**MODIFICATION OF DEVELOPMENT APPLICATION /
CONSTRUCTION CERTIFICATE - DACC 046/11 (S96 040/12)
NEW INDOOR AQUATIC CENTRE AND POOL - TONY
LUCHETTI SPORTS CENTRE GEORDIE STREET LITHGOW
NSW 2790**

To assess and recommend determination of Section 96 Modification of Consent S96 040/12 of DACC 046/11. Recommendation will be for approval subject to conditions

Map 1: showing carparking and road design

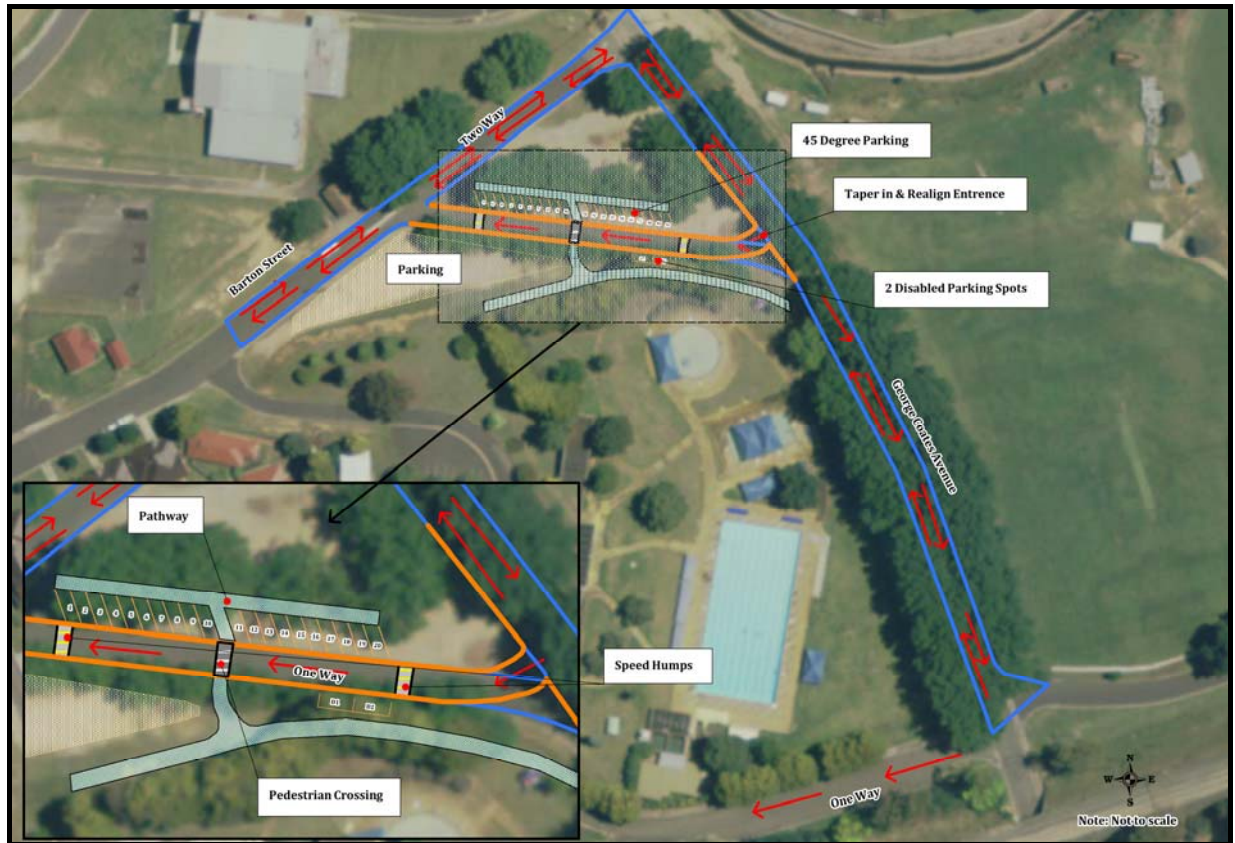
The reasoning for the amended condition and deletions is that Barton Street would remain open for vehicles to exit the carpark. This would create a better traffic flow than the original traffic layout plan and would increase the safety in the area by providing better site vision for vehicles.

The north eastern side of Barton Street (near the show ground entry) would be constructed to two ways (currently 2 lanes for a one way direction). This would provide road access for vehicles that are not using the pool facilities and would provide a safer access for pedestrians between the carpark and the pool entry.

A new parking area is proposed along the northern edge and western side of Barton Street. This modification proposes to provide 50 parking spaces to be 45° to the existing road pavement. This will enable the car park to be created on level with the new entry to the site.

It is further proposed that there would be two raised traffic calming devices (speed humps) installed at either end of Barton Street as well as realignment works at the intersection with George Coates Avenue to inhibit speeding through this area and increase safety. There will be no stopping zones implemented along both sides of George Coates Avenue. Two disabled parking spaces and a drop off/pick up parking space would be provided near the entrance.

Fifty (50) new forty five (45) degree car parking spaces are to be constructed along the northern edge of Barton Street. These car spaces are to be clearly signposted and line-marked and are to be constructed in accordance in accordance with Council's Off Street Off Street Parking Development Control Plan and AS 2890.6

The eastern end of Barton Street that is currently signposted as "one-way", accommodating only for eastern travelling vehicles is to be converted to "two-way" to accommodate for vehicles travelling in either direction, in conjunction with the closure of Barton Street.
